**Re: Engineering Geology Assessment-Addendum I
Lot 15, Ski Lake Estates No. 3
6640 East 1100 South
Huntsville, Utah
Job No. 145150**

The purpose of this letter is to respond to the geology review comments⁴ provided by Simon Associates, LLC, third-party consultant, hired by Weber County to review the referenced geology assessment letter.

PHOTO EXHIBIT
LOT 15, SKI LAKE ESTATES NO. 3
6640 EAST 1100 SOUTH
HUNTSVILLE, UTAH

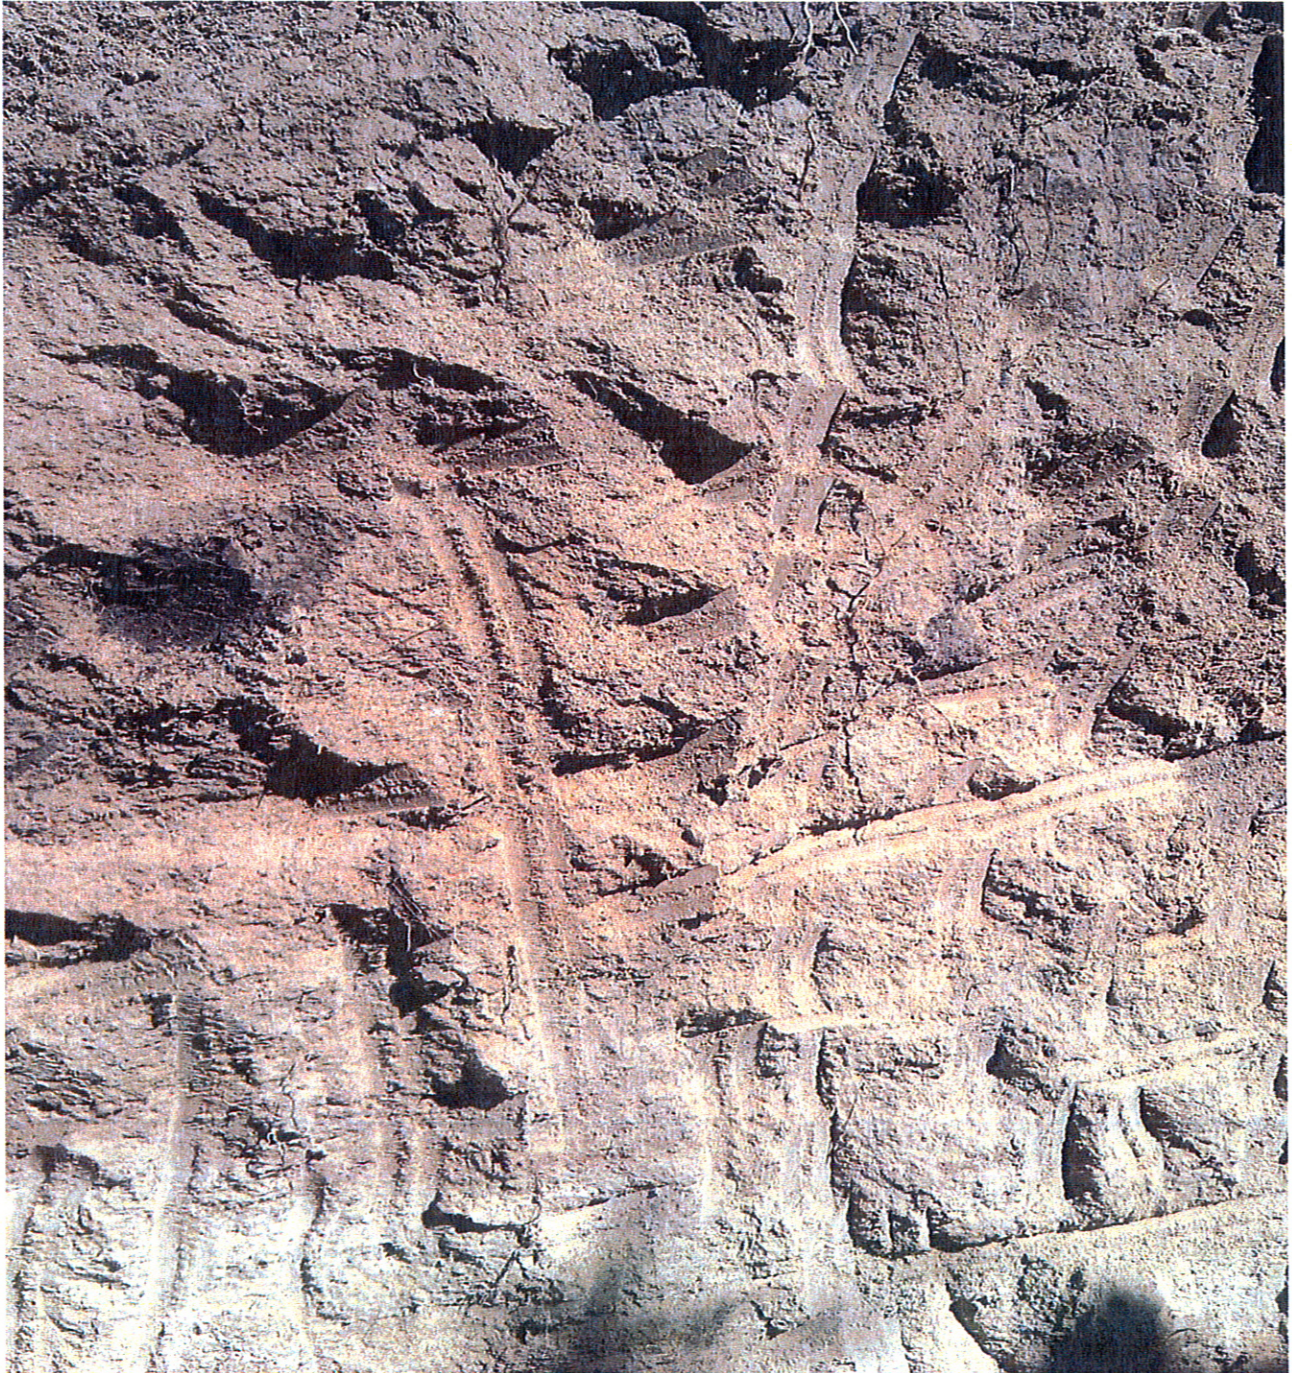
Review Comment 3 states: "On page 5 of the July 13, 2015.EEI report, EEI states: "on June 22, 2015, a geotechnical engineer from Earthtec Engineering returned to the lot with the excavator and oversaw the excavation of an additional test pit (TP-5) in the area of the proposed house on the lot as well as extending TP-3 down slope to the elevation of TP-4. This was done to provide additional subsurface observations in order to better understand the shallow subsurface geology at the site. Test Pit TP-5 and the extension of TP-3 were not logged but were photographed by the engineer." SA recommends Weber County request the annotated photographs of TP-5 and the extension of TP-3 on 6-22-15.

TP-3 was photographed as shown in Exhibit 1 through 3, Appendix A. No photographs of TP-5 were taken, and this test pit was backfilled.

FIGURE 3

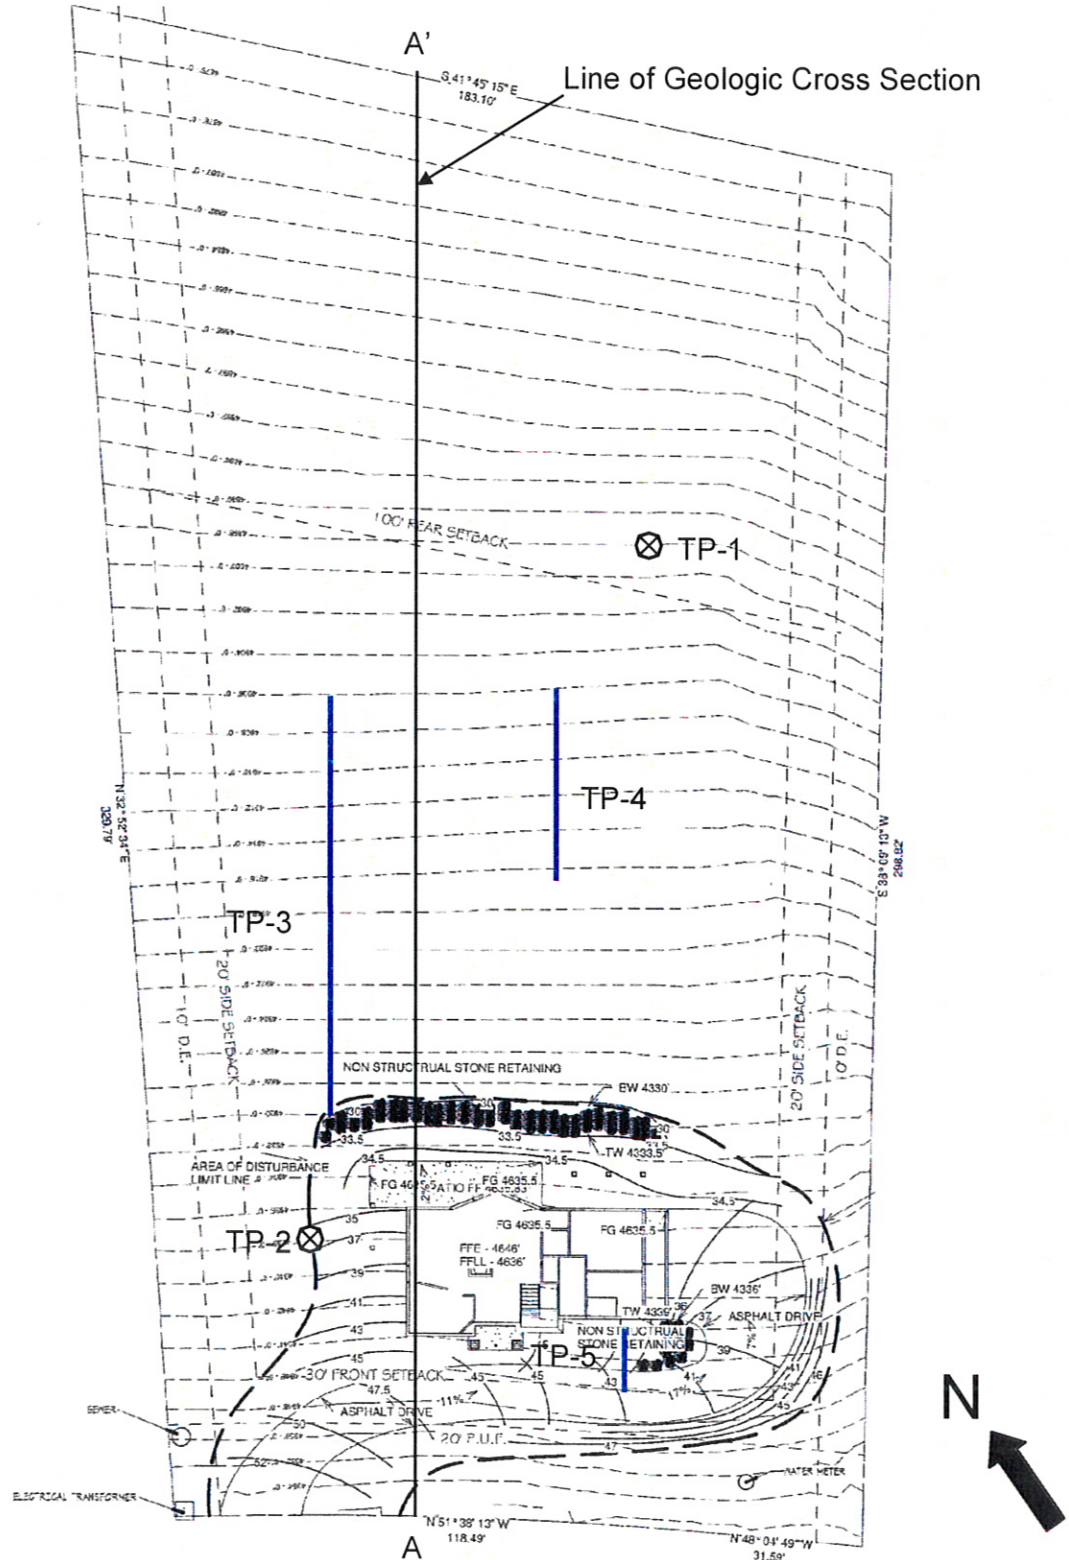
Review Comment 4 states: "SA recommends Weber County request EEI provide an updated site plan (Figure 3) depicting the approximate length of the test pits, particularly the extension of TP-3.

See the revised Figure 3, Appendix B. Test Pit 5 was approximately 4-5 feet long.
